Watermark Project

Response to submission from University of New South Wales

Prepared for
Shenhua Australia Holdings Ltd

Project No. G1501 October 2014
www.ageconsultants.com.au ABN 64 080 238 642

Figure 3-1 Cross-section through Southern Mining area/alluvium (Base EIS)

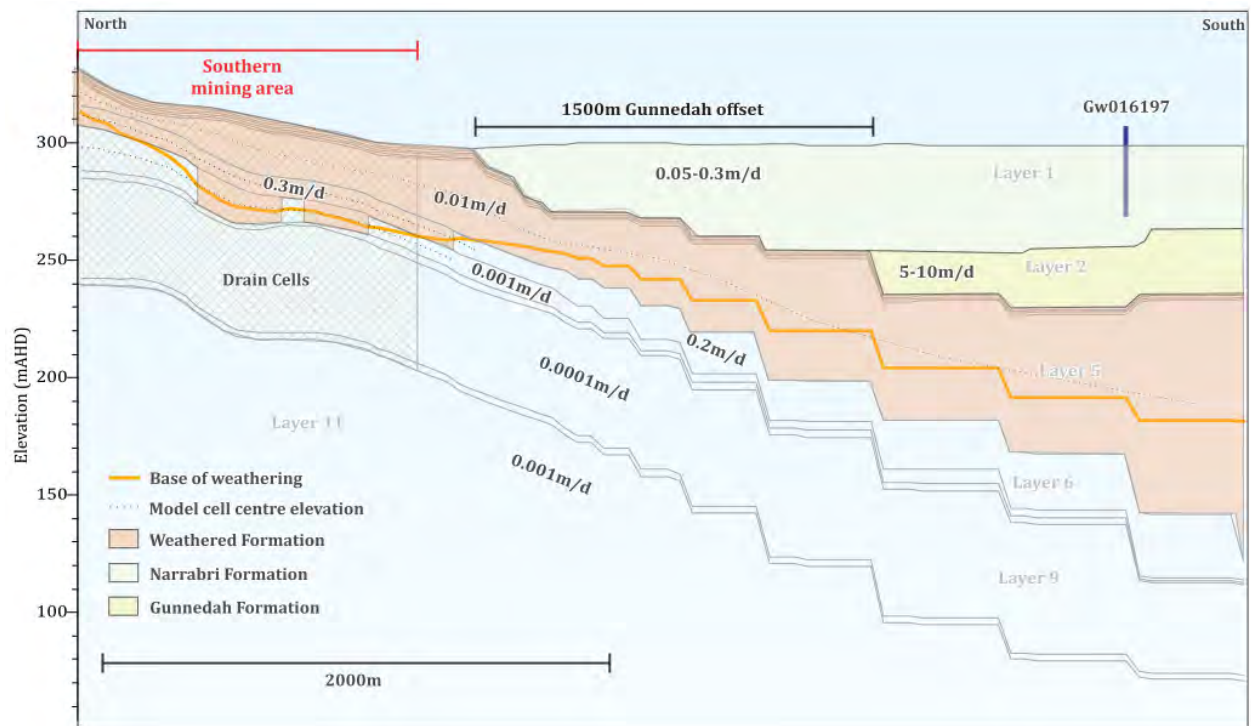
After reviewing a graphic in the EIS UNSW commented that ‘....zones of bedrock weathering that might increase connectivity were not indicated.’ It is correct the graphic did not represent a weathering zone, however the groundwater model did simulate the weathering profile in the proposed mining area and also underneath the alluvial aquifer to ensuring the alluvium and coal measures were represented as hydraulically interconnected.

Figure 3-1 shows a cross-section through the EIS groundwater model, indicating the hydraulic conductivity adopted within each model layer. The mapped depth of weathering has been highlighted to illustrate how the model represented the weathering rock zones.

Figure 3-1 illustrates the groundwater model presented in the EIS adopted a relatively permeable connection (0.01 m/day) between the proposed mining area, and the saturated groundwater system in the alluvial formations.

Figure 3-2 Cross-section through Southern Mining area/alluvium (Permian K+ 1 mag.)

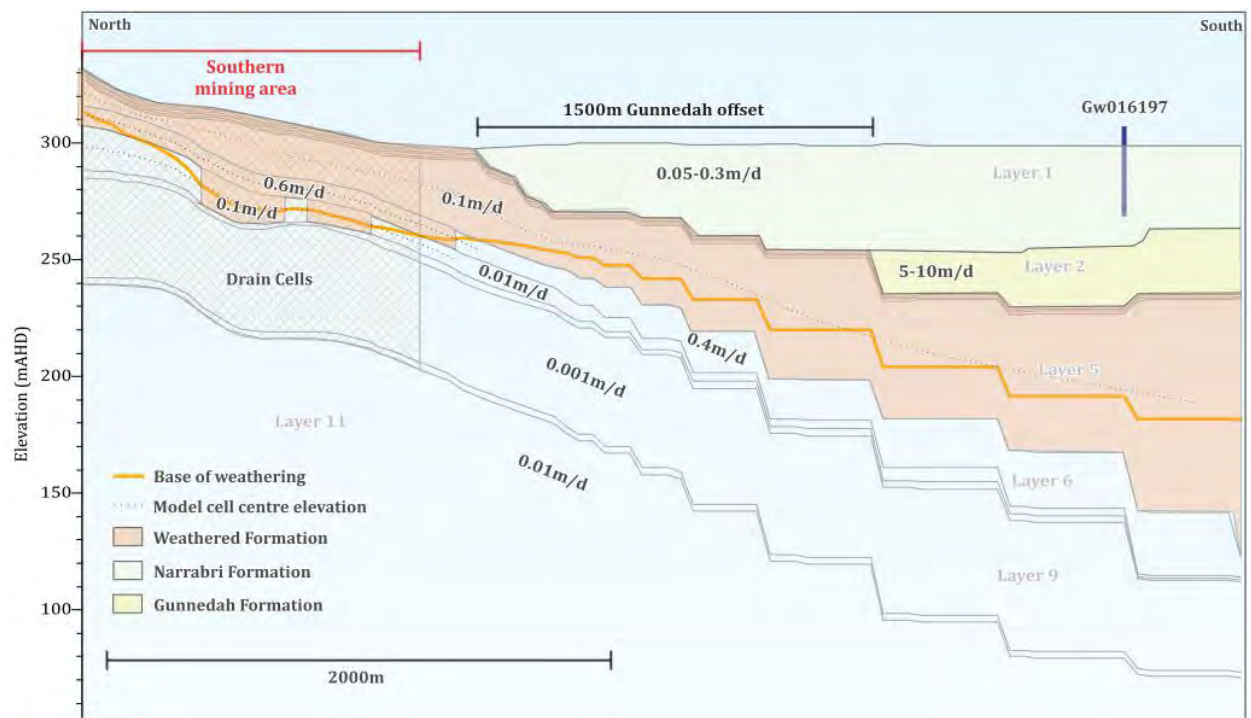
The sensitivity analysis conducted for the EIS varied the hydraulic conductivity of the fresh and weathered rock. Figure 3-2 presents a cross section through a version of the model, which assumed a hydraulic conductivity rates of ten times higher than the base case for the weathered zone.

Figure 3-2 shows that the sensitivity analysis simulated a permeable connection between the proposed mining area and the alluvium with a weathered zone hydraulic conductivity of 0.1 m/day. This represents hydraulic conductivity is equivalent to 'unconsolidated silty sand/ fine sand' (Fetter, 2001). Uncertainty realizations presented within the EIS also simulated permeable weathered zones with hydraulic conductivity exceeding 0.1 m/day between the Southern Mining area and the alluvium (EIS Appendix 9, Figure 3.5b).

Figure 3-3 Cross-section showing colluvial extent (W-E)

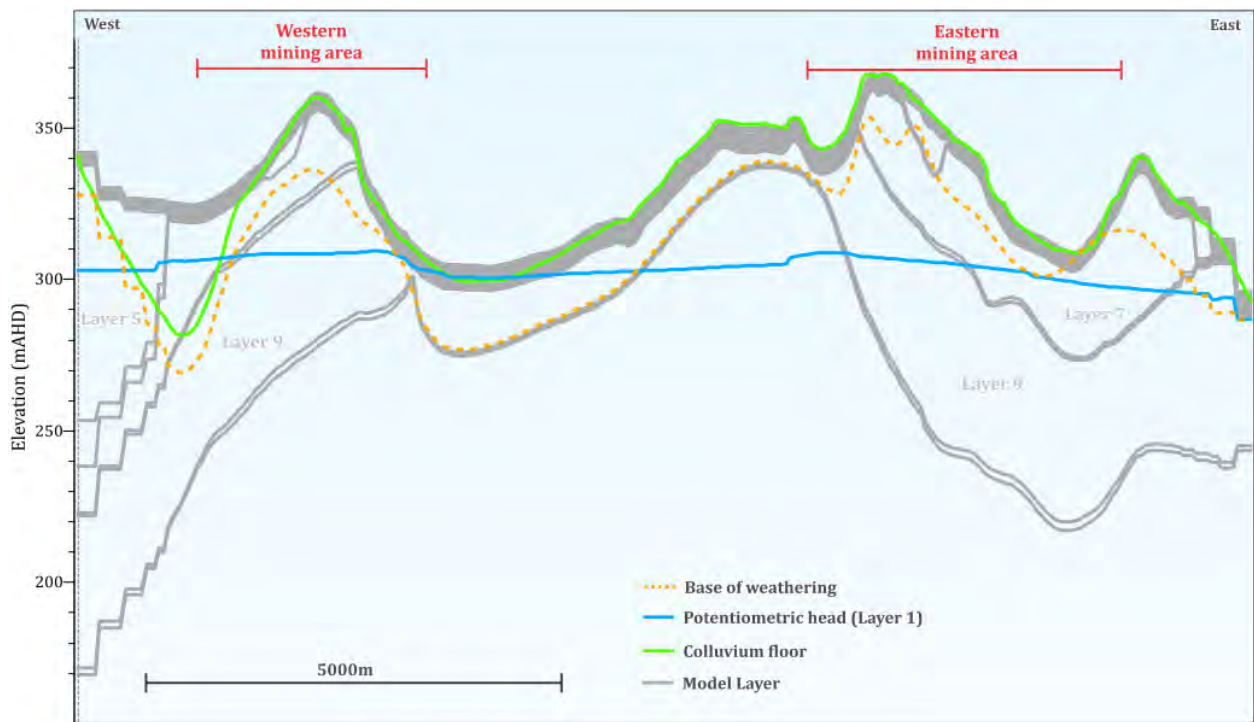
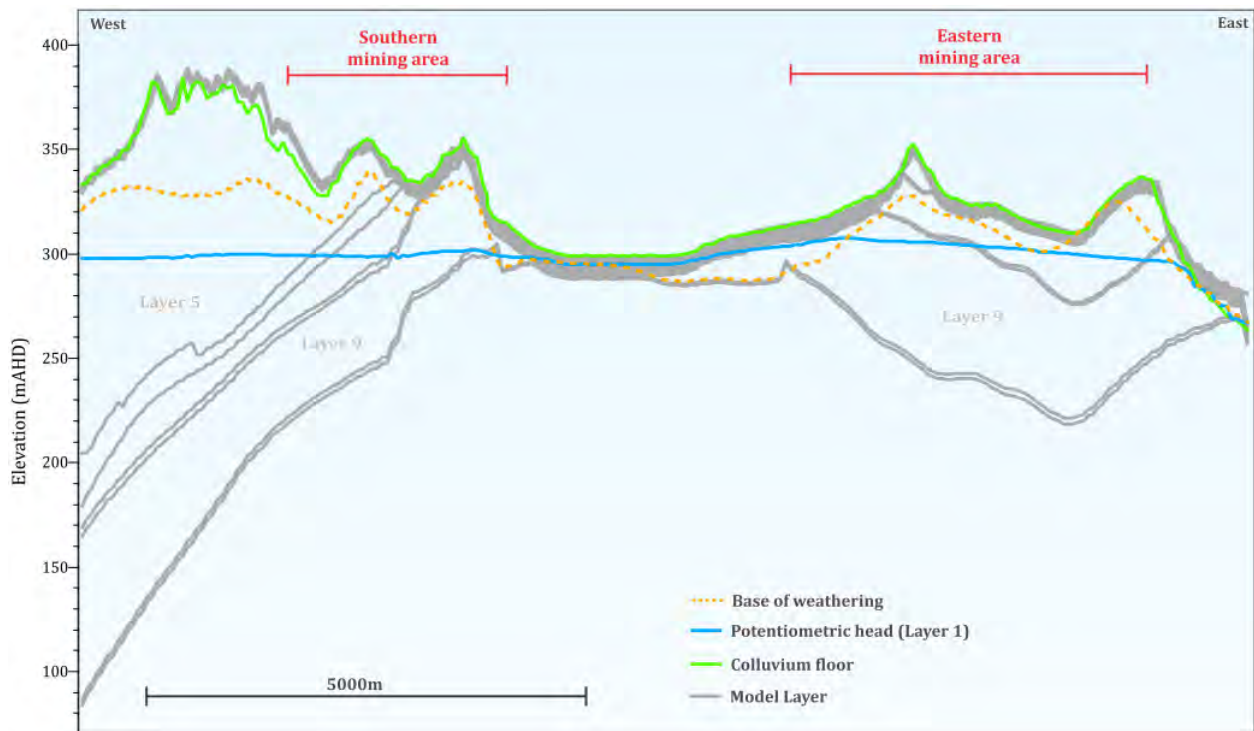
UNSW commented the EIS model did not represent colluvium layers that were depicted in geological cross sections. The EIS model did represent the presence of colluvium, not as a discrete model layer, but as part of the weathered zone. The colluvium, by its nature is a relatively thin, of limited extent and is largely unsaturated over the majority of the project area. Figure 3-3 and Figure 3-4 show cross sections through the EIS groundwater model with the mapped floor of the colluvium, the weathering surface and water table simulated in the model.

The figures highlight that representing the colluvium with the weathered material readily accounts for this relatively insignificant unit. The colluvium is only saturated in a small area adjacent to the Western Mining area. There are two monitoring bores installed in this area (WM0035A and WM0293A). Permeability testing of the colluvial deposit recorded a relatively low permeability from 0.0006 to 0.008 m/day. The hydraulic conductivity of the model layers where the colluvium exists in the saturated zone is 0.01 m/day, which is conservatively high and considered an appropriate representation of this unit in the EIS model.

FIGURE No:
3-8

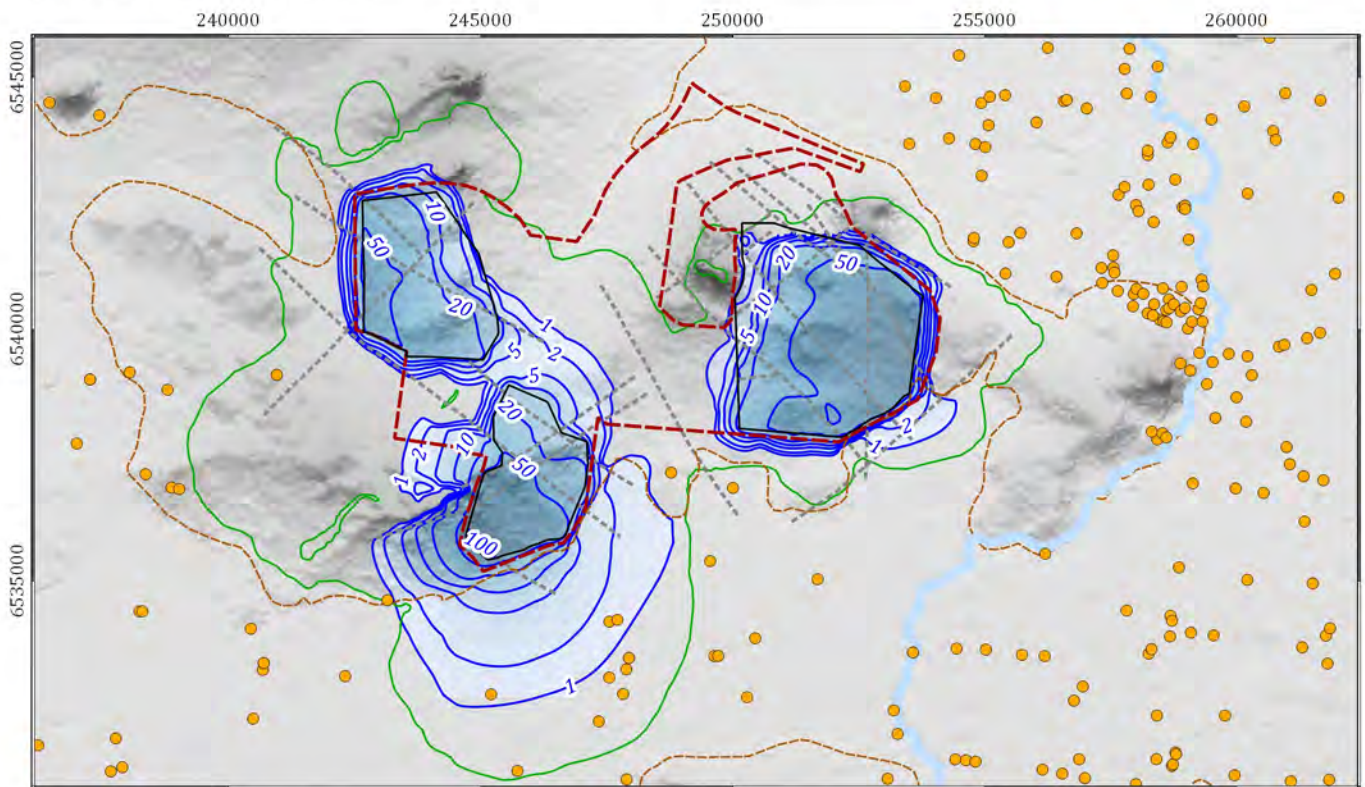
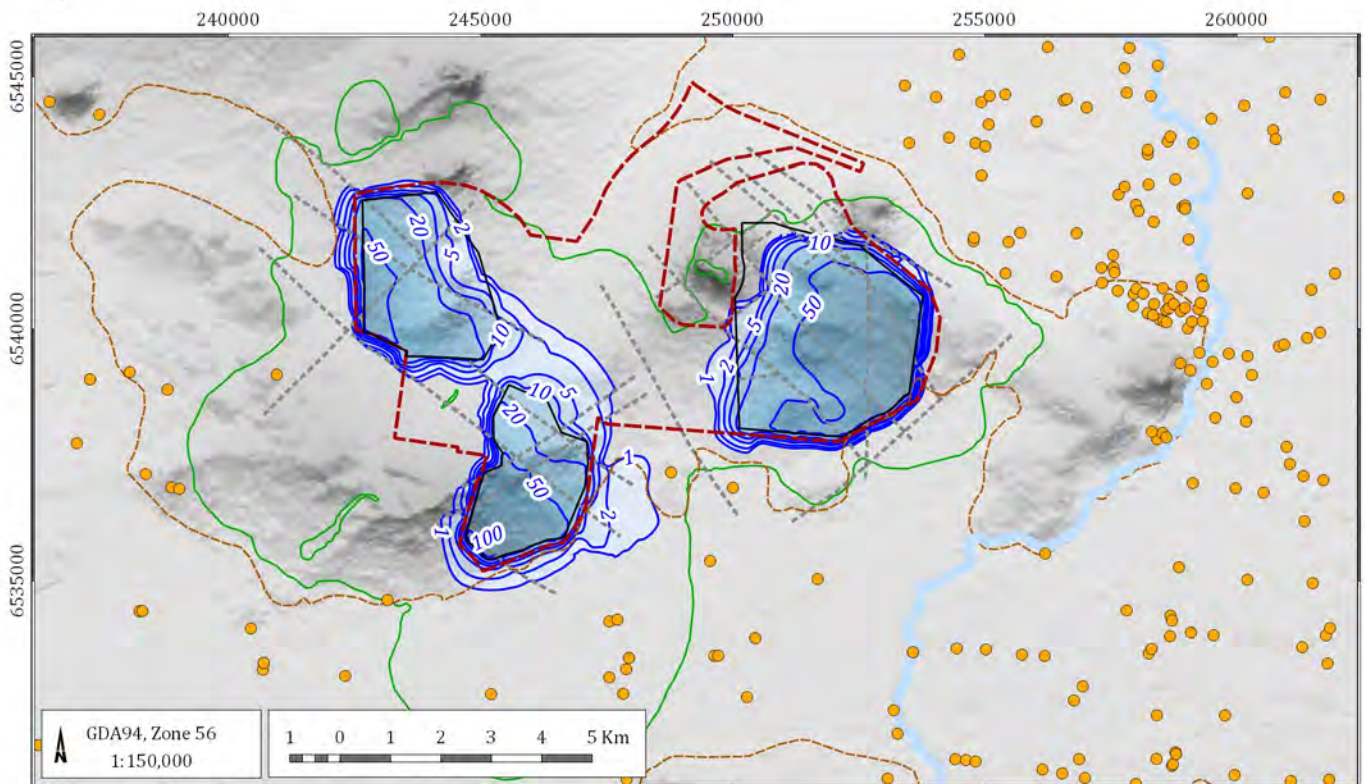
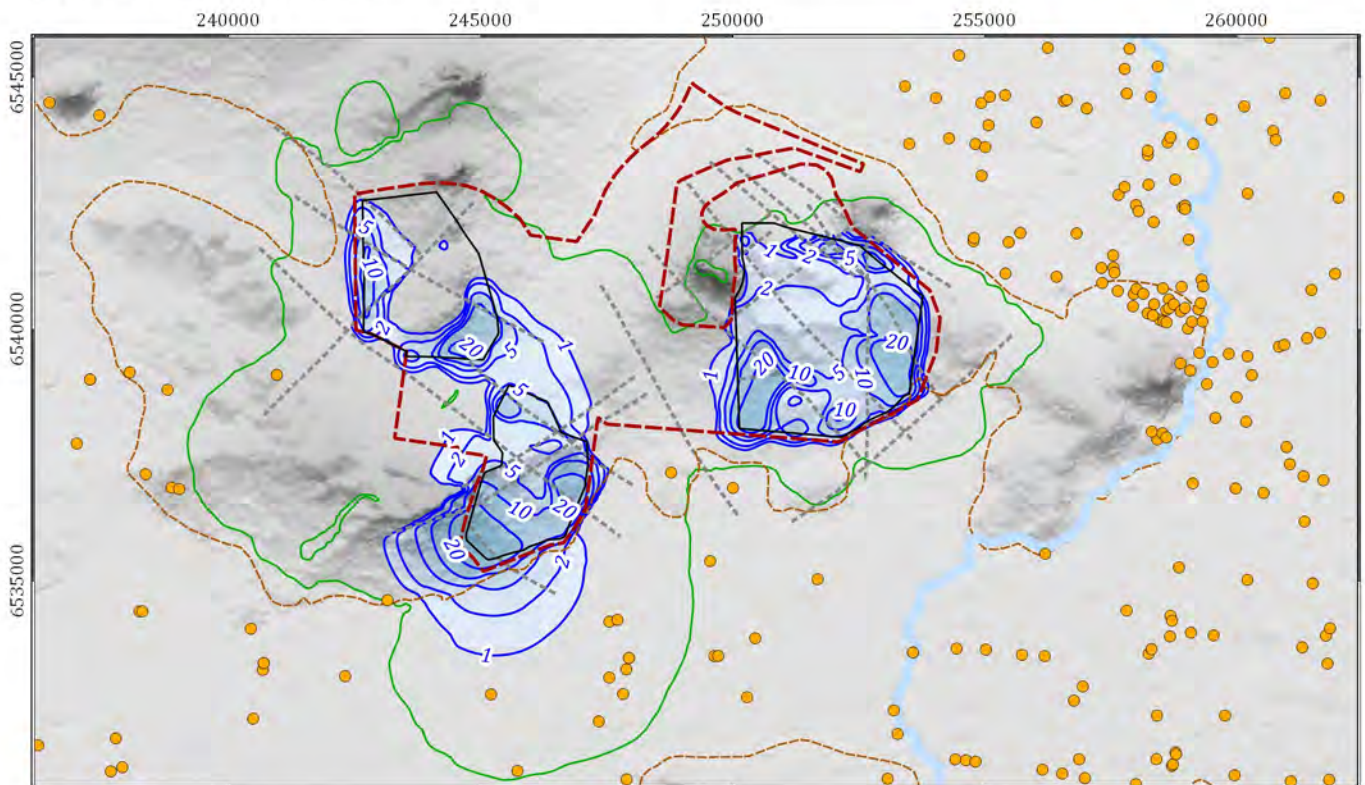
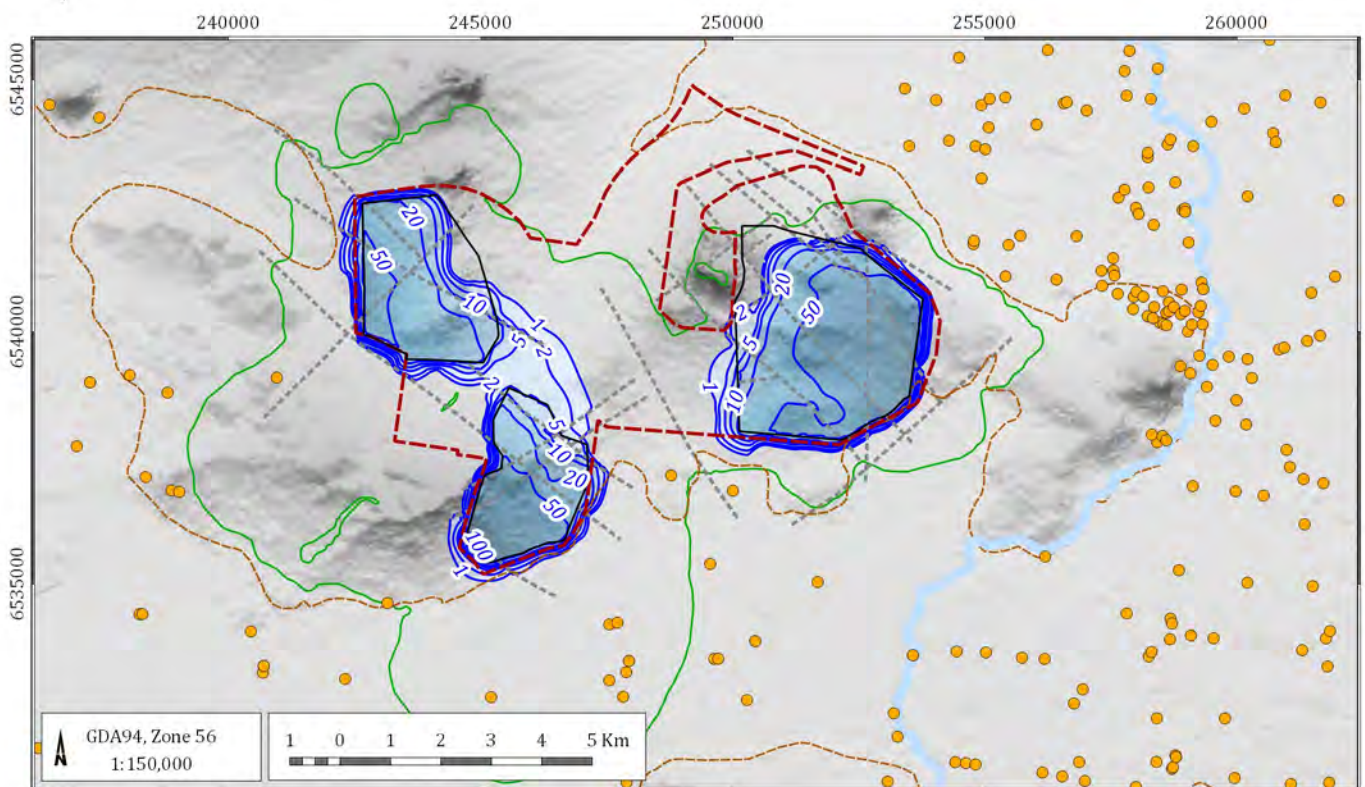
Figure 3-8 and Figure 3-9 present the maximum groundwater drawdown (at any time during the mine life) predicted by Scenarios 12 and 13 within the layers representing the Gunnedah Formation and the Clare sandstone.

The results show that revised groundwater drawdown extents are very similar to results presented in the EIS, and less than the maximum drawdown predicted by the uncertainty analysis. This is because the presence of more permeable formations in closer proximity to the proposed mining areas buffer the drawdown. This is because of the larger volumes of water are released from storage in the Clare sandstone and the alluvium before significant depressurisation occurs.

Figure 3-10 Pumping test results (90BL254822 – from GHD Hydrogeological report, 2012)

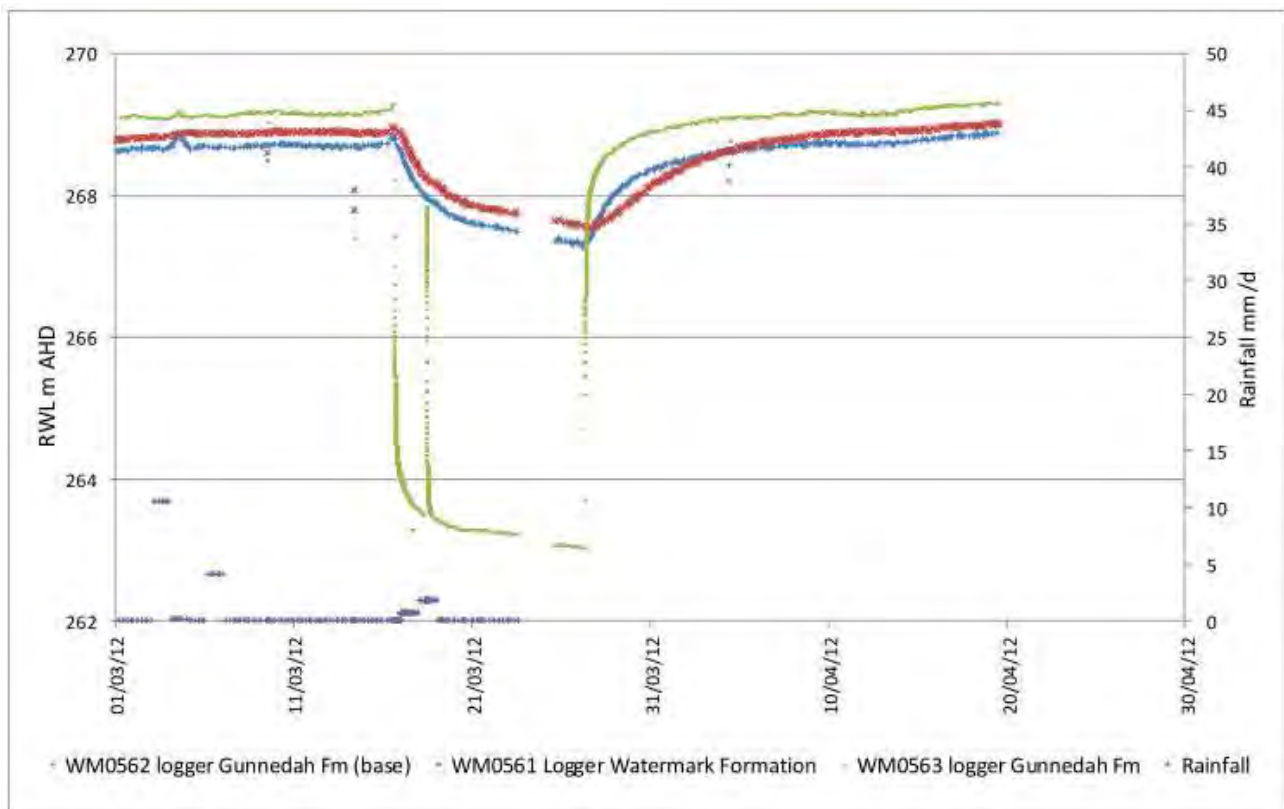
UNSW do not indicate why they recommend a pumping test period of 30 days. A pumping test should be of sufficient length to observe a response in the formations being tested, and in the case of the tests undertaken for the EIS the adopted pumping period was sufficient.

Bore 90BL254822 installed within the Gunnedah Formation was pumped for two days and monitoring undertaken in the alluvium and coal measures. A very muted response was observed in the coal measures whilst pumping from the overlying Gunnedah Formation, indicating a limited hydraulic connection between the two units (refer Figure 3-10).

Figure 3-12 Hypothetical faults - Scenario 15

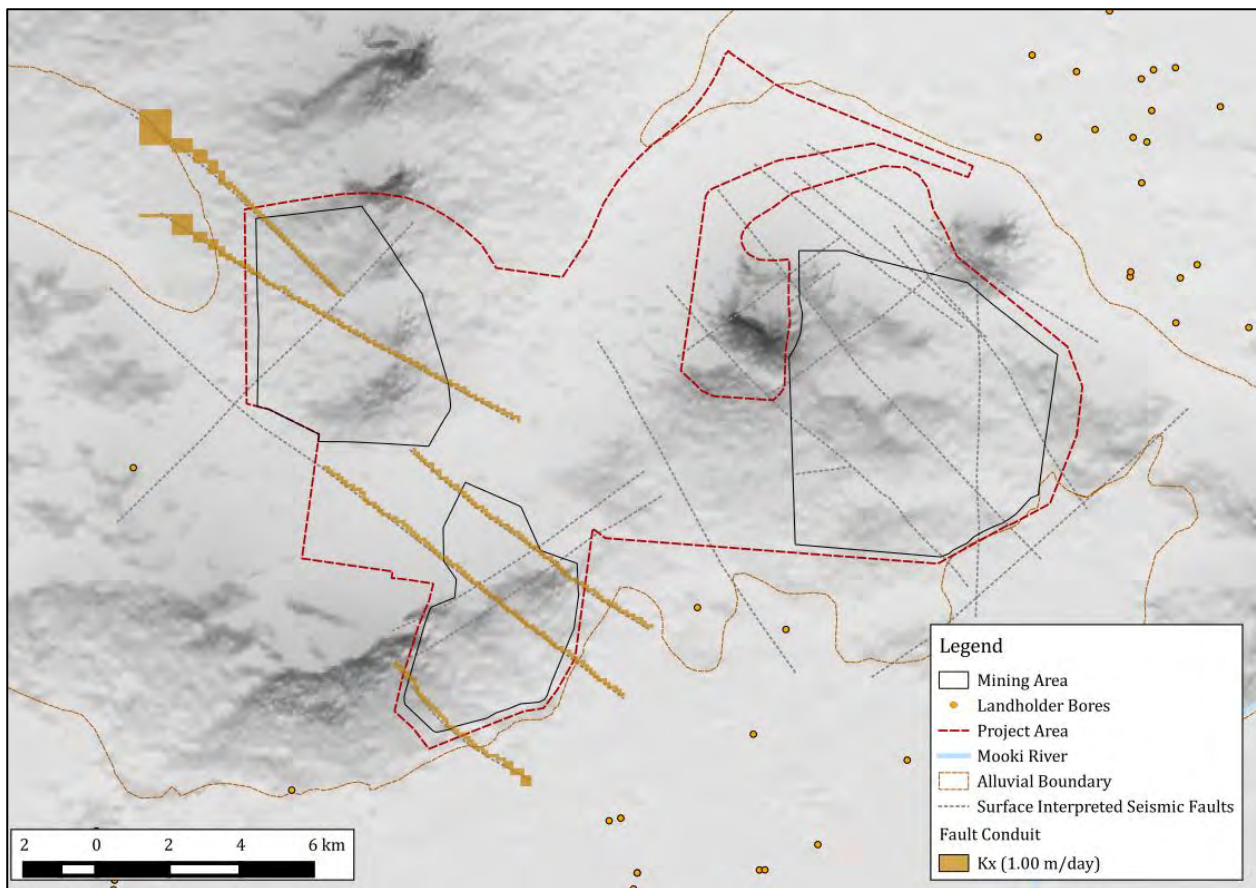
Whilst we consider the representation of the faults in the EIS model was the most appropriate approach, and other conceptualisations were explored including removing the faults in the sensitivity analysis, we have undertaken further modelling of scenarios to consider UNSW's comments. The model with the adjusted Gunnedah and Clare sandstone as outlined previously was further modified removing the faults completely. A second model was also developed simulating a series of 'hypothetical' highly permeable conductive fault conduits running directly from underneath the alluvium, and through the Western and Southern Mining areas. These hypothetical faults were represented by setting columns of model cells with high permeability and storage. Figure 3-12 shows the locations of the hypothetical faults with Table 3.7 summarising the model setup for each scenario.
